Fwd: combined FOPH- Yadadri TPS

CUSTOMER:	TELANGANA STATE POWER GENERATION CORPORATION LTD TELANGANA, INDIA 5 x 800 MW YADADRI TPS, NALGONDA
CONSULTANT:	TATA CONSULTING ENGINEERS LIMITED BANGALORE
DESIGNER:	BHARAT HEAVY ELECTRICALS LTD POWER SECTOR PROJECT ENGINEERING MANAGEMENT NOIDA

TITLE GA DRAWING FOR COMBINED FUEL OIL PUMP HOUSE
(UNLOADING THROUGH ROAD TANKER CUM PRESSURISING & HEATING P/H)

DRAWING NO. PE-DG-417-166-A003
SHEET 01 OF 01 REV. 03

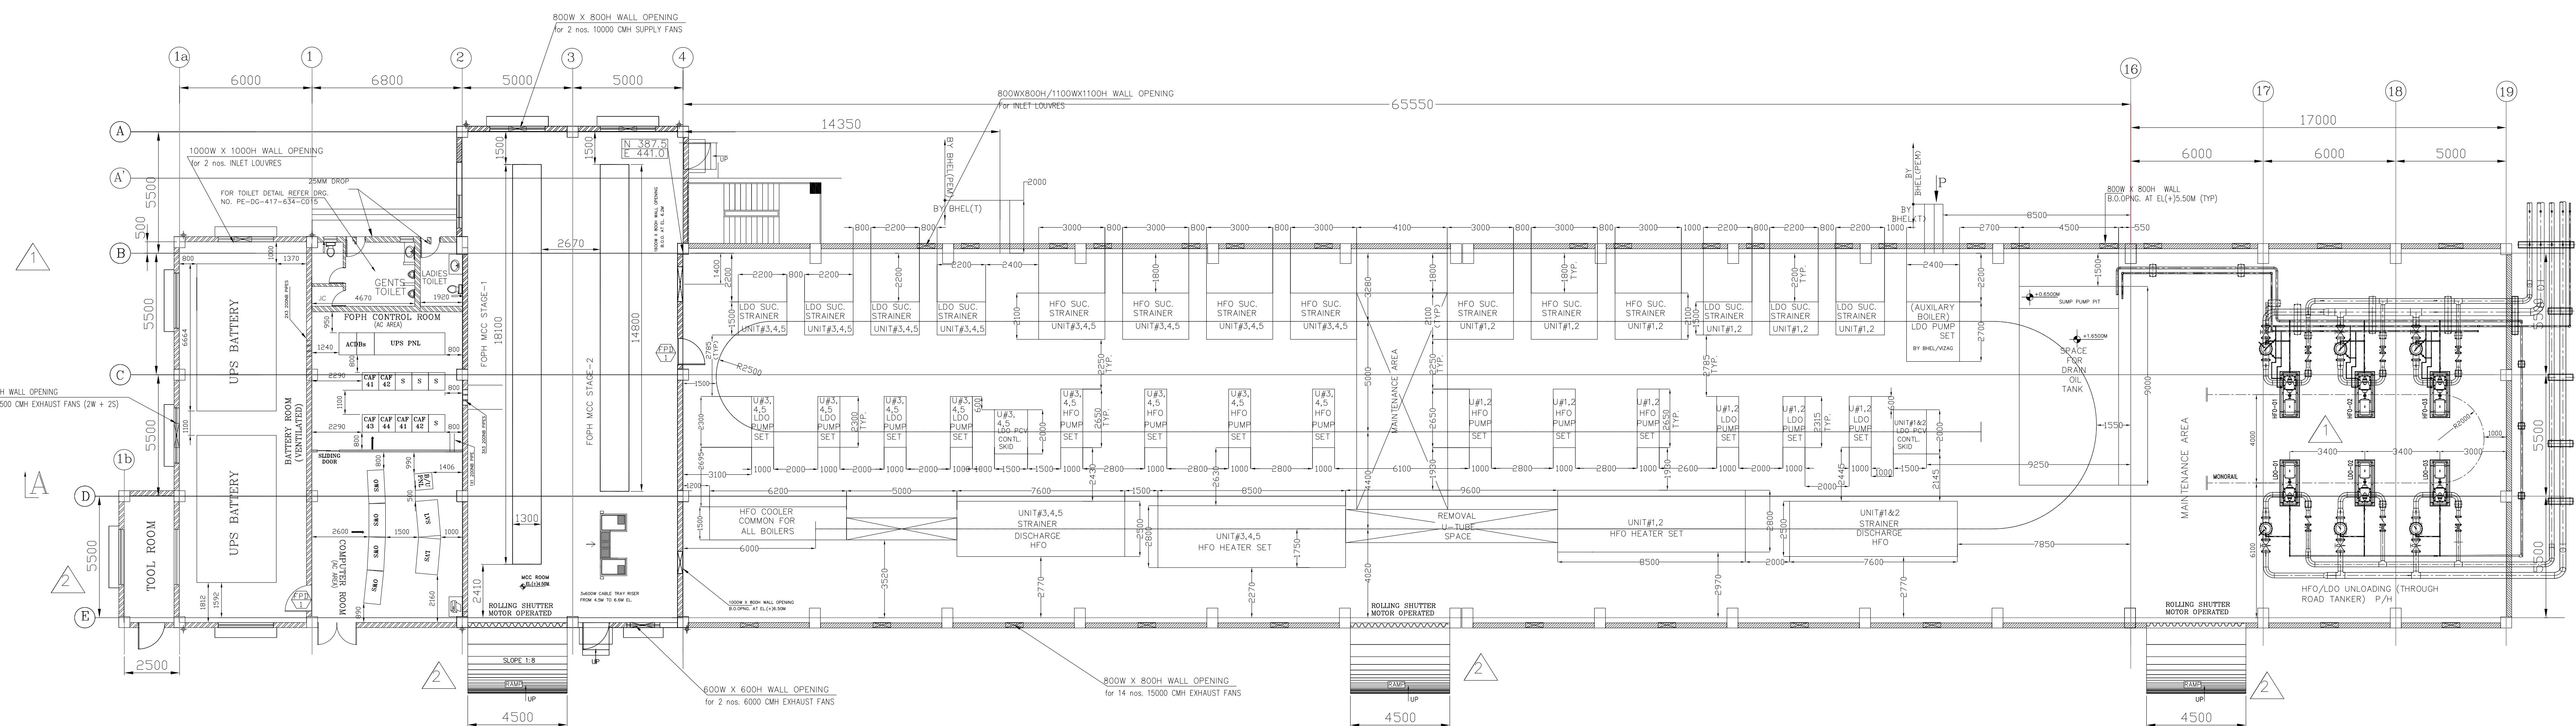
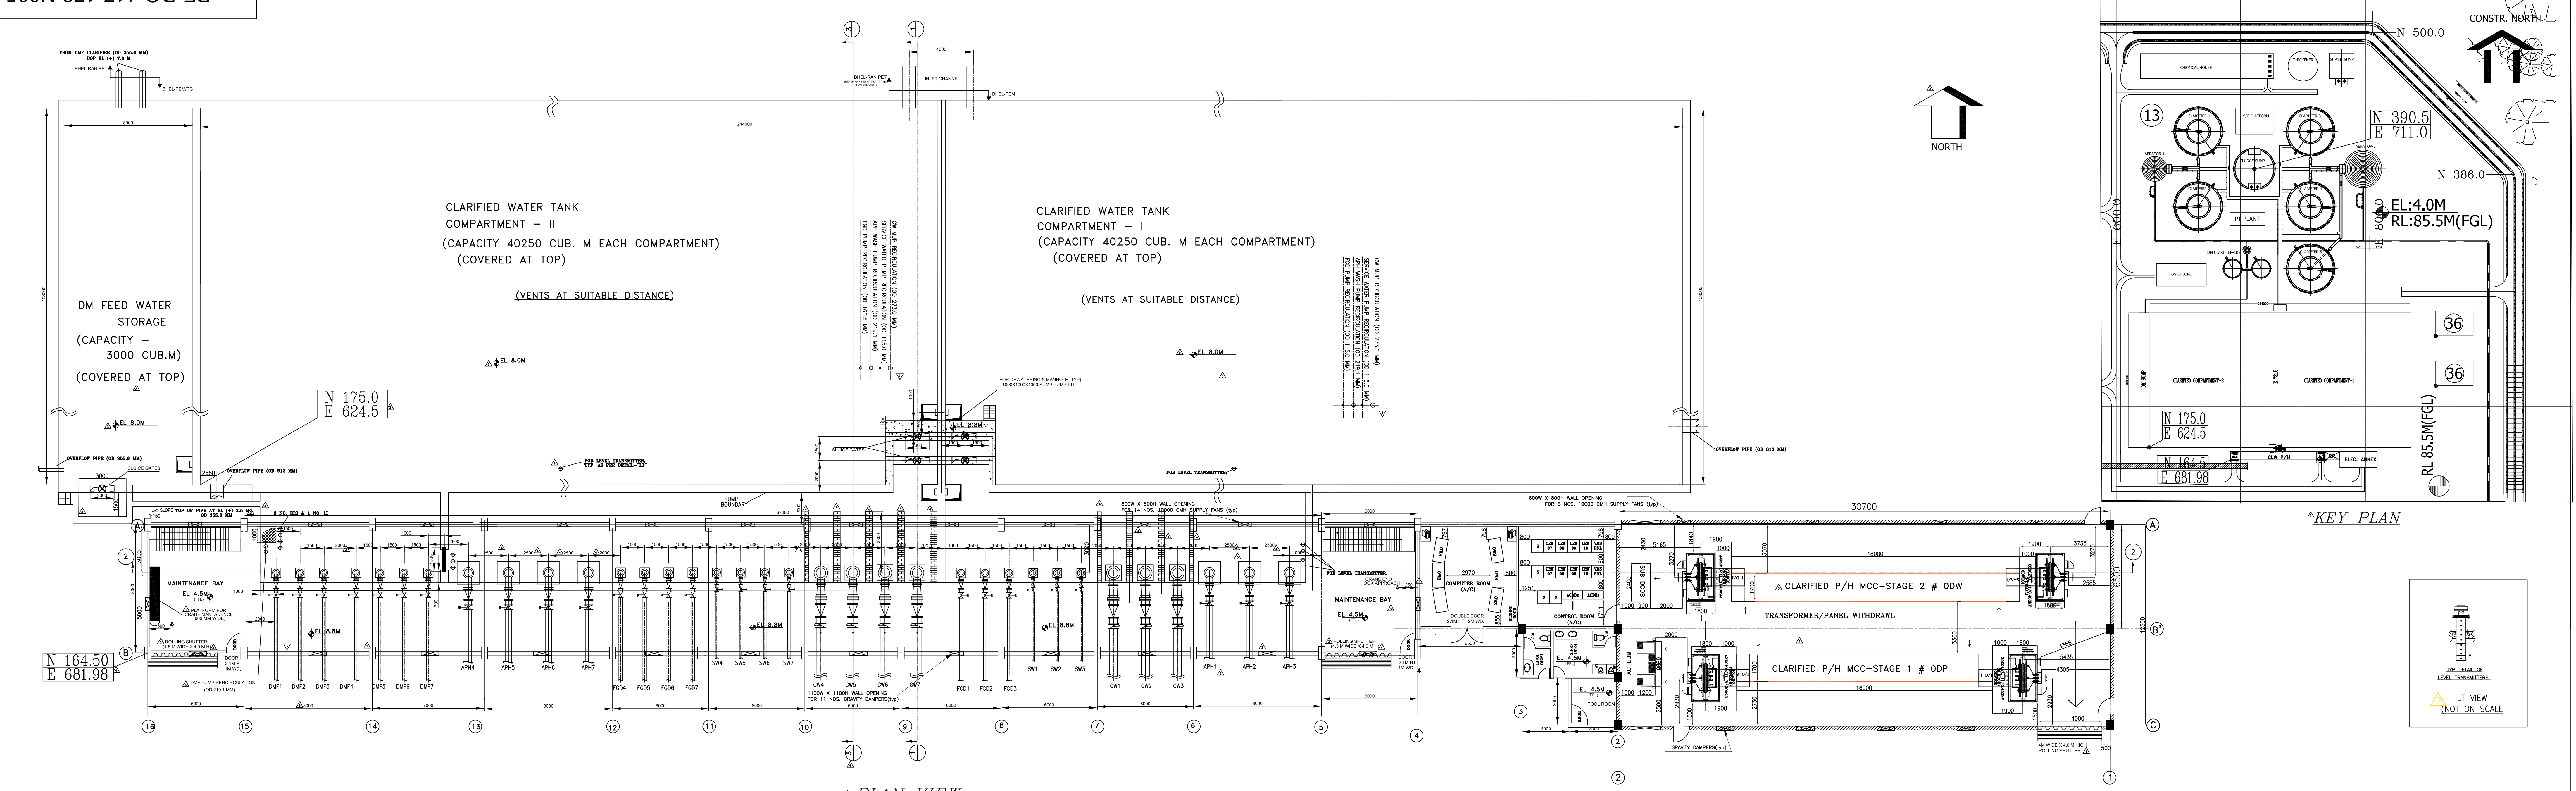
Referring to your below mail, the area indicated in PEM Drg. 0-00-056-11165 (i.e 2700x2400) is meeting our requirement.
Regards
